State of California  
AIR RESOURCES BOARD

**Final Statement of Reasons for Rulemaking,  
Including Comment Summaries and Agency Responses**

PUBLIC HEARING TO CONSIDER THE PROPOSED REGULATION ON THE  
COMMERCIALIZATION OF ALTERNATIVE DIESEL FUELS

Public Hearing Dates: **February 19, 2015 & September 24-25, 2015**  
Agenda Item Nos.: **15-2-3; 15-7-1**

**Figure 8. Change in Arable Land Plus Permanent Crops: 2004–2006 to 2010–2012**

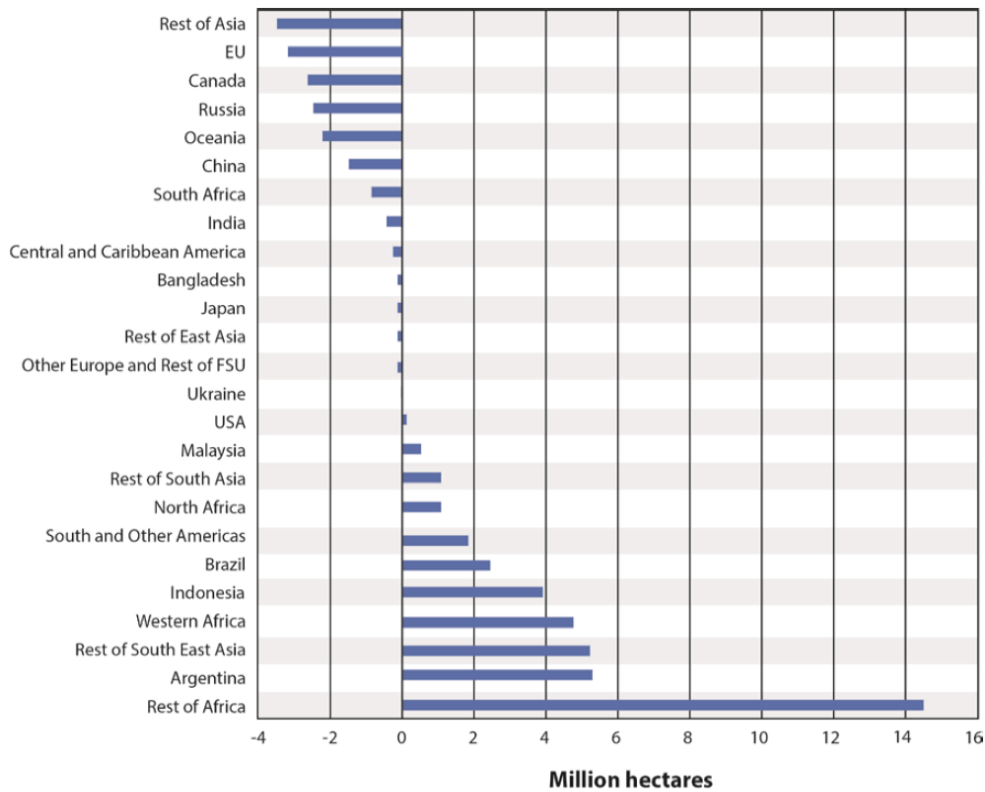
Figure 8 does show that Western Africa, and the “Rest of Africa”, have significant extensive changes in arable land plus permanent crops (see Attachment 2 for countries included in the Africa regions of Figure 8). However, the study indicates that “the extent to which extensive expansion in African countries was caused by high world prices is small for the simple reason that higher world prices were not transmitted to growers in many African countries. Babcock and Iqbal cite a number of studies to support this conclusion.

**Figure 3a**  
**Results of Sierra Analysis of Statewide NOx Increases Due to Biodiesel Use in All NTDEs under the Proposed ADF Regulation**

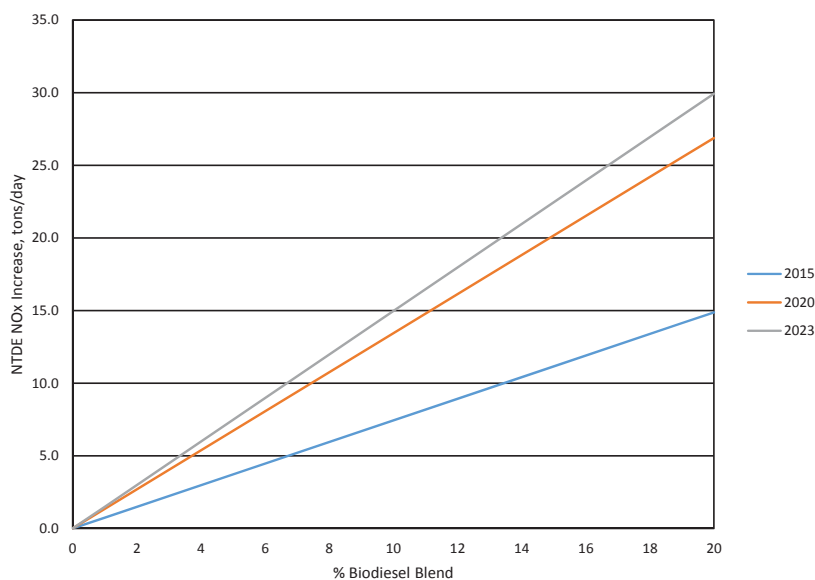
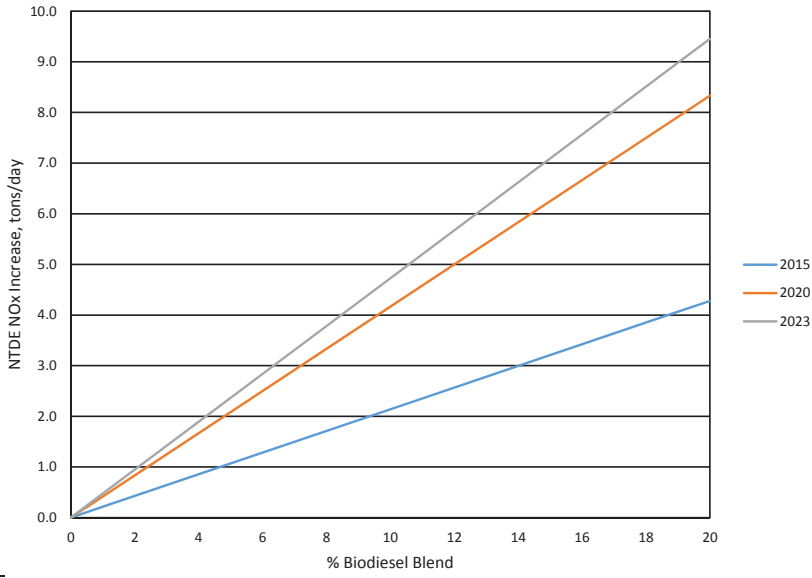
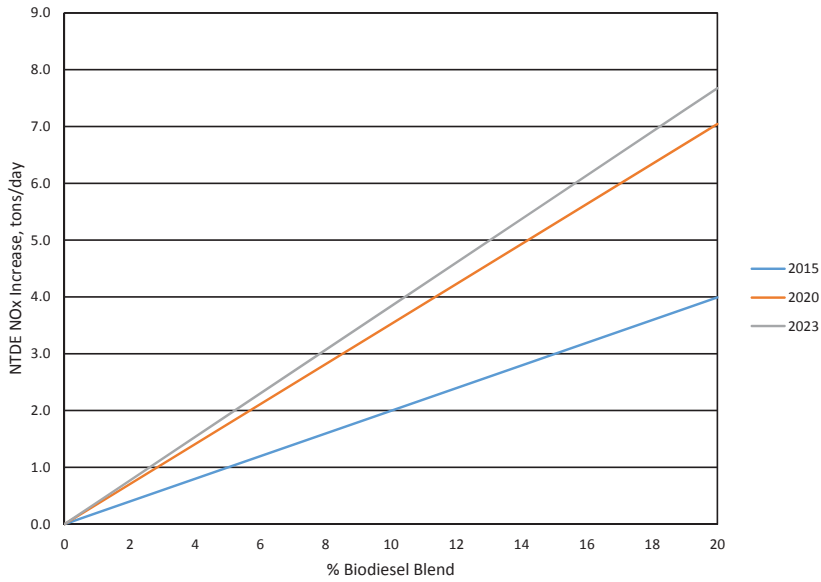
As shown, the potential NOx increases from extensive use of higher level biodiesel blends in NTDEs is quite large. Furthermore, although the results shown in Figures 3a through 3c are maximum potential impacts, they can again be simply scaled for other cases. For example, in order to estimate statewide NOx increases from B20 use in 50% rather than 100% of NTDEs, one would simply multiply the value of 30 tons per day by 0.5 (50/100) to arrive at a 15 ton per day increase. Finally, it should be noted that the values in Figures 3a through 3c reflect both on- and off-road NTDEs as described above for the Sierra analysis of B5 impacts.

Figure 2-1  
NOx Emission Increases Observed in Biodiesel Research Cited in Staff ISOR

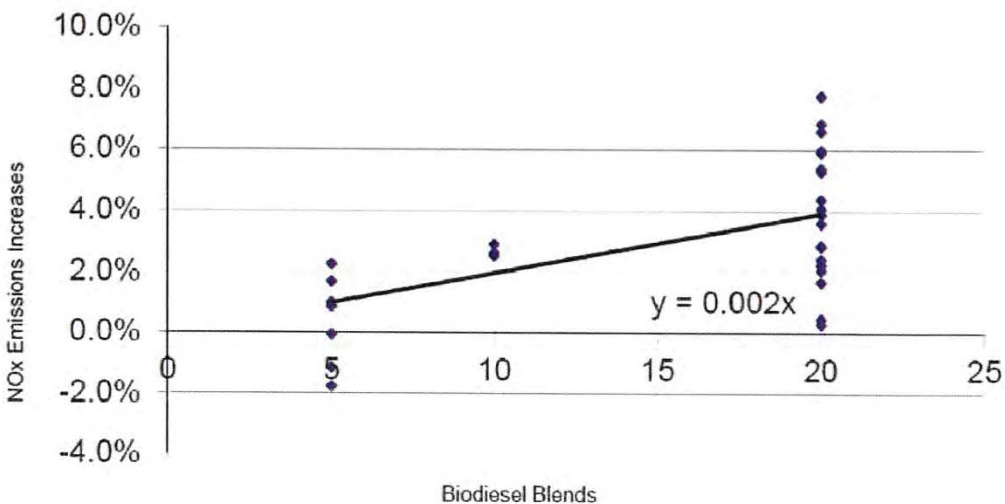
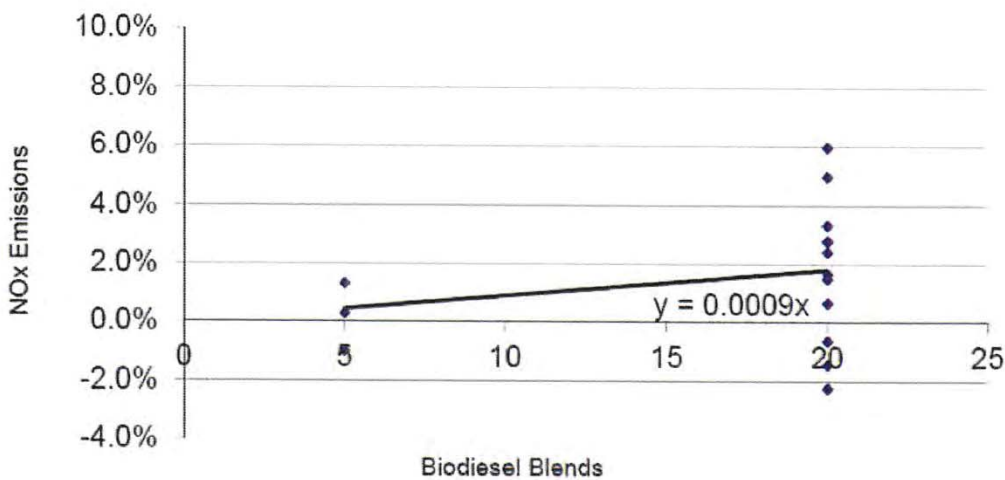
- The same result – reduced NOx emissions for some fuels and engines – has sometimes been observed in past research, as evidenced by the emissions data considered by CARB staff in ISOR Figure B.3 (reproduced in Figure 2.1 below). As shown, some animal-based B5 and B20 fuels reduced NOx emissions while others increased NOx emissions with the overall conclusion being that NOx emissions increase in direct proportion to biodiesel content of the blends and that there is no emissions threshold.
- Increasing cetane is known to generally reduce NOx emissions and has already been proposed by CARB as a mitigation strategy for increased NOx emissions from biodiesel<sup>14</sup>. The unusual cetane number response in the blending and the high cetane number of the B5-animal fuel may account for the results presented in the recently released study.

Figure 2-1 reproduces two exhibits from Appendix B that show increasing trends for NOx emissions with the biodiesel blending level. Based on the slopes of the trend lines,

Figure 2-2  
Impact of Biodiesel Blends on Percent NOx Change for the 5.9L ISB Engine Operation Over the FTP Cycle

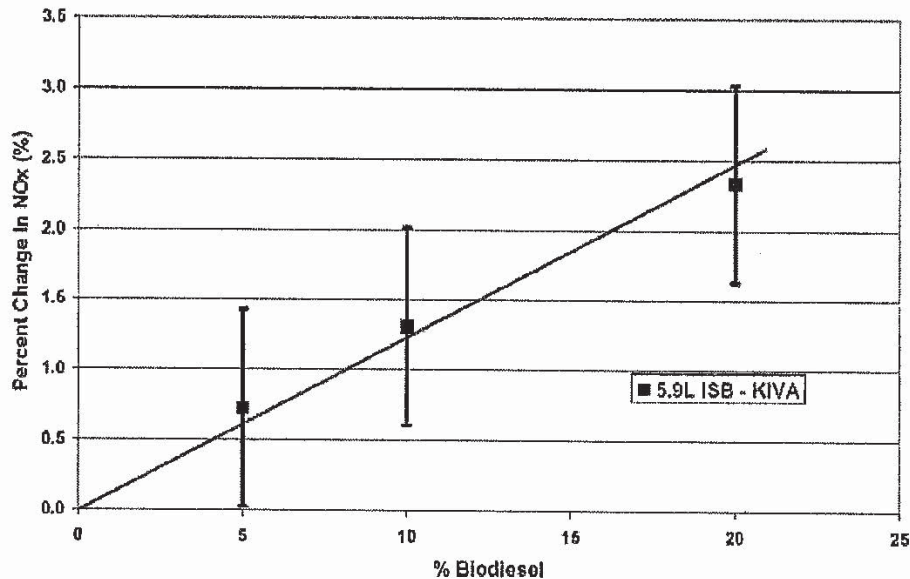
The study notes that two other studies “show that NOx emissions increase nearly linearly with the increase in the percentage of biodiesel added to diesel fuel.” Eckerle’s Figure 21 (reproduced below as Figure 2-2) indicates a NOx emissions increase at B5, which is the basis for the statement in the abstract that “Results also show that for biodiesel blends containing less than 20% biodiesel, the NOx impact over the FTP cycle is proportional to

the blend percentage of biodiesel.” The authors clearly believe that biodiesel fuels have NOx emission impacts proportional to the blending percent at all levels including B5.

Figure 3-2a  
 Durbin 2011 Assessment: FTP NOx Emissions Increases for Animal-based Biodiesel Blends (2006 Cummins Engine)

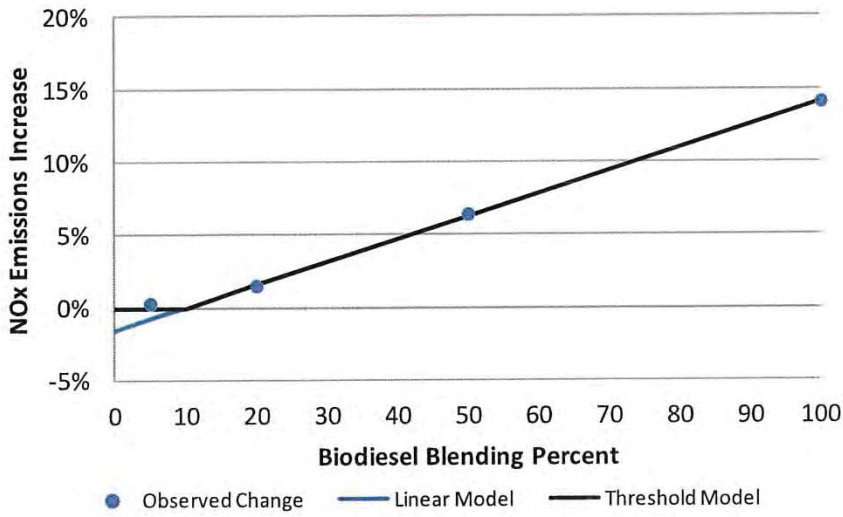
Figures 3-2a and 3-2b display the trend of NOx emissions with blending percent for the animal-based biodiesel on the FTP test cycle as reported by Durbin 2011 and as re-assessed in this report using regression analysis, respectively. As Figure 3-2a shows, the NOx percent change values reported by Durbin 2011 appear to follow the Staff Threshold model in that NOx emissions are not materially increased at B5, but are increased significantly at B20 and above. As a result, the blue trendline in the figure (fit from the B20, B50 and B100 data points) has a negative intercept.

Because the ULSD data point is subject to more uncertainty and appears to be biased high compared to the regression line, the NOx percent changes computed by Durbin 2011 are themselves biased. The trendline result in Figure 3-2a that appeared to be supportive of the Staff Threshold model now appears to be the result of biases in the ULSD and B5 emission averages.

Figure 3-2b  
 Re-assessment of FTP NOx Emissions Increases for Animal-based Biodiesel Blends (2006 Cummins Engine)

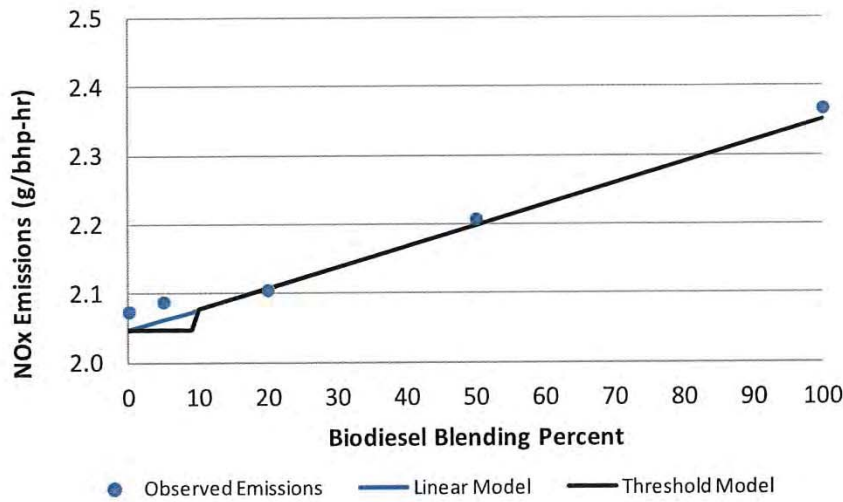
Figure 3-2b paints a very different picture from the data. Here, the ULSD and B5 data points stand above the weighted regression line (blue) developed from the data for ULSD, B20, B50 and B100. In the data used to fit the regression line, the ULSD data point has the largest uncertainty ( $\pm 0.013$  g/bhp-hr) while the other three data points (B20, B50, and B100) have uncertainties of  $\pm 0.002$  g/bhp-hr (one case) and  $\pm 0.001$  g/bhp-hr (two cases). Considering all of the data, the B5 data point has the second highest uncertainty ( $\pm 0.007$  g/bhp-hr). The regression line closely follows a linear model with a high  $R^2$  (0.981) considering the weighted errors, while the ULSD and B5 points lie above it.

Figure 3-4  
 Durbin 2011 Assessment: ISO 8178 Cycle NOx Emissions Increases for Soy-based Biodiesel Blends (1998 Kubota Engine, Test Series 1 and 2 Combined)

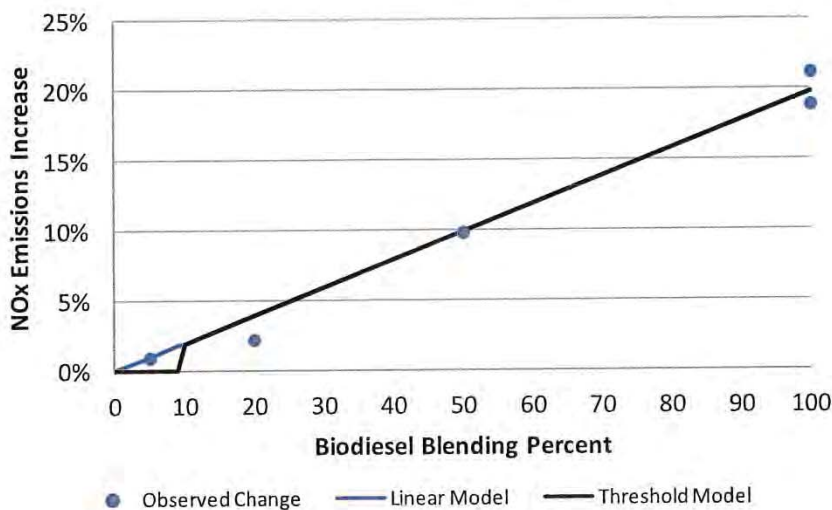
Figure 3-4 displays the trend of NOx emissions with blending percent for the first and second test series combined. As the figure shows, the available data points scatter around the trendline determined from the emission change percentages (not from regression analysis). The B20 data point falls below the trend line while the two B100 data points bracket the trend line. It is not possible to explain the divergence of the B20 data point

**Figure 1. CARB Biodiesel Forecasts**

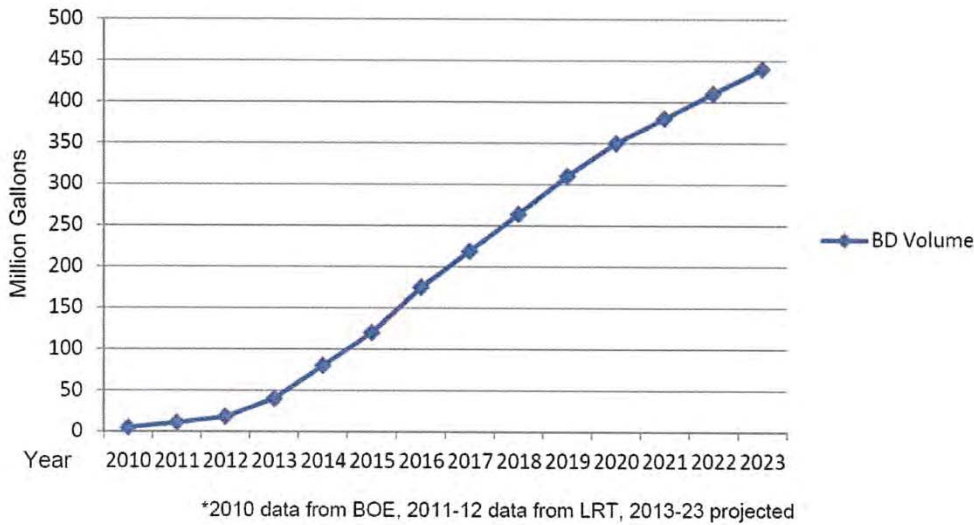
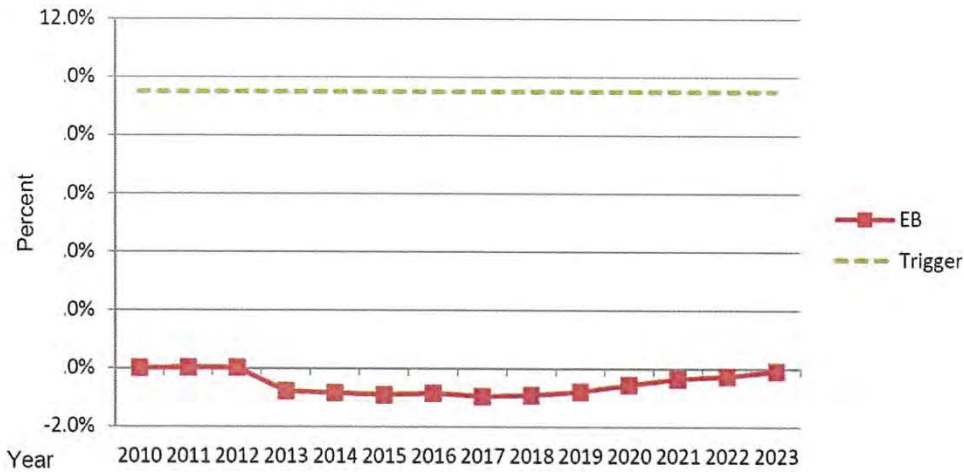
Source: CARB Initial Statement of Reasons. Note that Figure 6.5 is reproduced directly from the ISOR, which is missing some increments on the y-axis.

Figure 3-2a  
 Durbin 2011 Assessment: FTP NOx Emissions Increases for Animal-based Biodiesel Blends (2006 Cummins Engine)

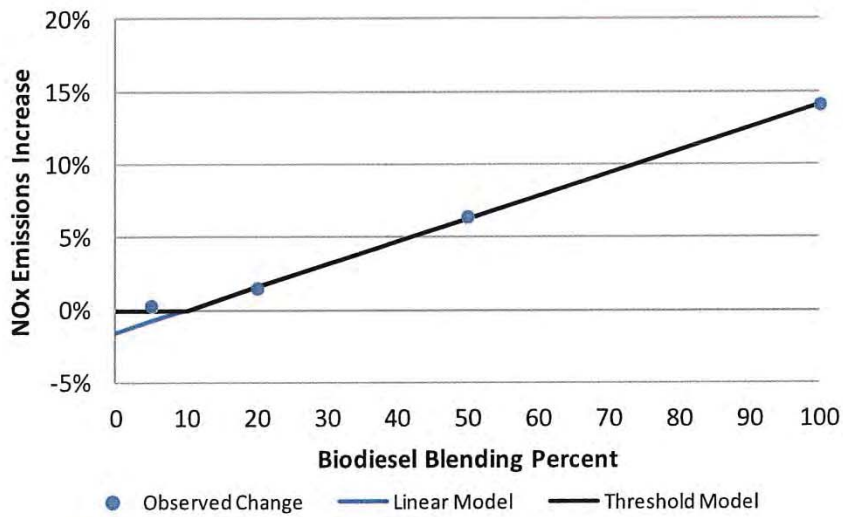
Figures 3-2a and 3-2b display the trend of NOx emissions with blending percent for the animal-based biodiesel on the FTP test cycle as reported by Durbin 2011 and as re-assessed in this report using regression analysis, respectively. As Figure 3-2a shows, the NOx percent change values reported by Durbin 2011 appear to follow the Staff Threshold model in that NOx emissions are not materially increased at B5, but are increased significantly at B20 and above. As a result, the blue trendline in the figure (fit from the B20, B50 and B100 data points) has a negative intercept.

Because the ULSD data point is subject to more uncertainty and appears to be biased high compared to the regression line, the NOx percent changes computed by Durbin 2011 are themselves biased. The trendline result in Figure 3-2a that appeared to be supportive of the Staff Threshold model now appears to be the result of biases in the ULSD and B5 emission averages.

Figure 3-2b  
 Re-assessment of FTP NOx Emissions Increases for Animal-based Biodiesel Blends (2006 Cummins Engine)

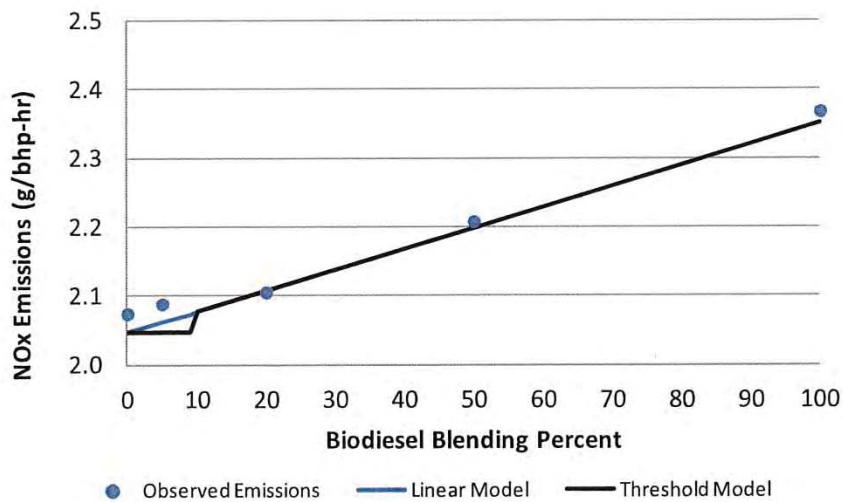
Figure 3-2b paints a very different picture from the data. Here, the ULSD and B5 data points stand above the weighted regression line (blue) developed from the data for ULSD, B20, B50 and B100. In the data used to fit the regression line, the ULSD data point has the largest uncertainty ( $\pm 0.013$  g/bhp-hr) while the other three data points (B20, B50, and B100) have uncertainties of  $\pm 0.002$  g/bhp-hr (one case) and  $\pm 0.001$  g/bhp-hr (two cases). Considering all of the data, the B5 data point has the second highest uncertainty ( $\pm 0.007$  g/bhp-hr). The regression line closely follows a linear model with a high  $R^2$  (0.981) considering the weighted errors, while the ULSD and B5 points lie above it.

Figure 3-4  
 Durbin 2011 Assessment: ISO 8178 Cycle NOx Emissions Increases for Soy-based Biodiesel Blends (1998 Kubota Engine, Test Series 1 and 2 Combined)

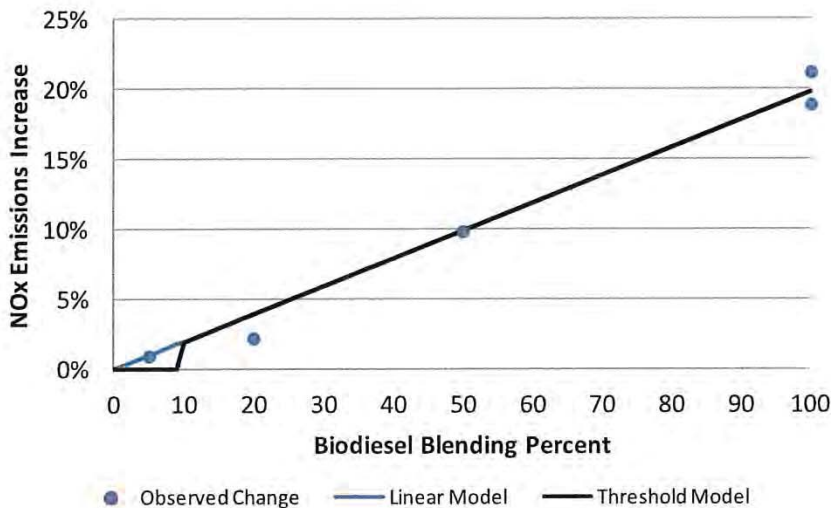
Figure 3-4 displays the trend of NOx emissions with blending percent for the first and second test series combined. As the figure shows, the available data points scatter around the trendline determined from the emission change percentages (not from regression analysis). The B20 data point falls below the trend line while the two B100 data points bracket the trend line. It is not possible to explain the divergence of the B20 data point

Figure 3-2a  
 Durbin 2011 Assessment: FTP NOx Emissions Increases for Animal-based Biodiesel Blends (2006 Cummins Engine)

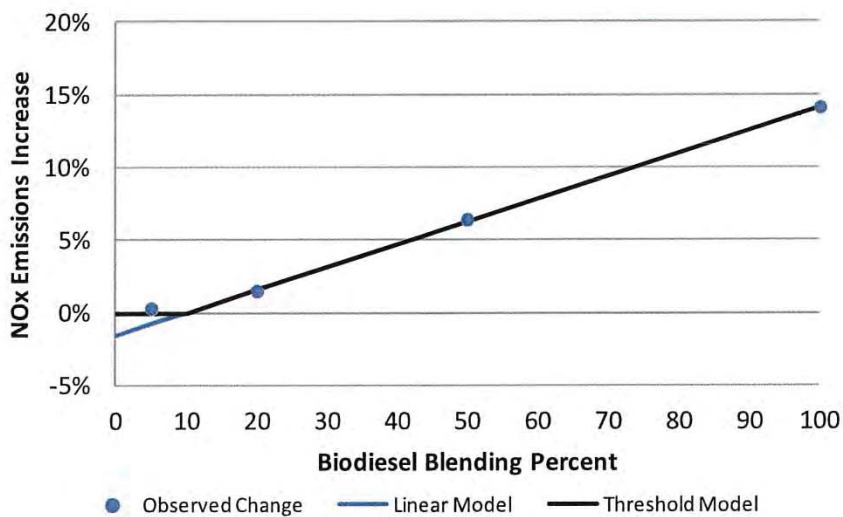
Figures 3-2a and 3-2b display the trend of NOx emissions with blending percent for the animal-based biodiesel on the FTP test cycle as reported by Durbin 2011 and as re-assessed in this report using regression analysis, respectively. As Figure 3-2a shows, the NOx percent change values reported by Durbin 2011 appear to follow the Staff Threshold model in that NOx emissions are not materially increased at B5, but are increased significantly at B20 and above. As a result, the blue trendline in the figure (fit from the B20, B50 and B100 data points) has a negative intercept.

Because the ULSD data point is subject to more uncertainty and appears to be biased high compared to the regression line, the NOx percent changes computed by Durbin 2011 are themselves biased. The trendline result in Figure 3-2a that appeared to be supportive of the Staff Threshold model now appears to be the result of biases in the ULSD and B5 emission averages.

Figure 3-2b  
 Re-assessment of FTP NOx Emissions Increases for Animal-based Biodiesel Blends (2006 Cummins Engine)

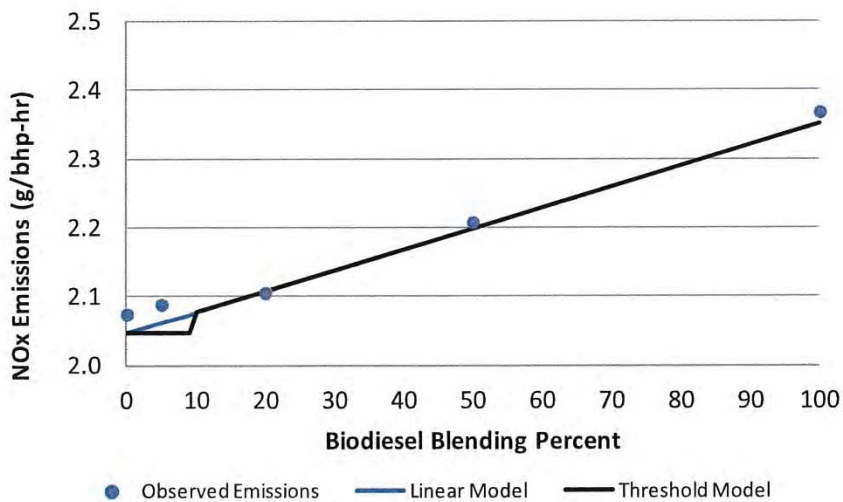
Figure 3-2b paints a very different picture from the data. Here, the ULSD and B5 data points stand above the weighted regression line (blue) developed from the data for ULSD, B20, B50 and B100. In the data used to fit the regression line, the ULSD data point has the largest uncertainty ( $\pm 0.013$  g/bhp-hr) while the other three data points (B20, B50, and B100) have uncertainties of  $\pm 0.002$  g/bhp-hr (one case) and  $\pm 0.001$  g/bhp-hr (two cases). Considering all of the data, the B5 data point has the second highest uncertainty ( $\pm 0.007$  g/bhp-hr). The regression line closely follows a linear model with a high  $R^2$  (0.981) considering the weighted errors, while the ULSD and B5 points lie above it.

Figure 3-4  
 Durbin 2011 Assessment: ISO 8178 Cycle NOx Emissions Increases for Soy-based Biodiesel Blends (1998 Kubota Engine, Test Series 1 and 2 Combined)

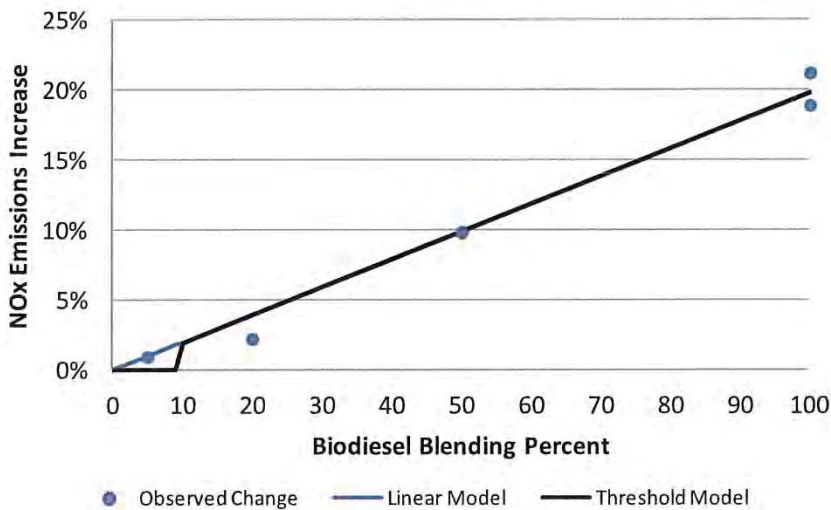
Figure 3-4 displays the trend of NOx emissions with blending percent for the first and second test series combined. As the figure shows, the available data points scatter around the trendline determined from the emission change percentages (not from regression analysis). The B20 data point falls below the trend line while the two B100 data points bracket the trend line. It is not possible to explain the divergence of the B20 data point
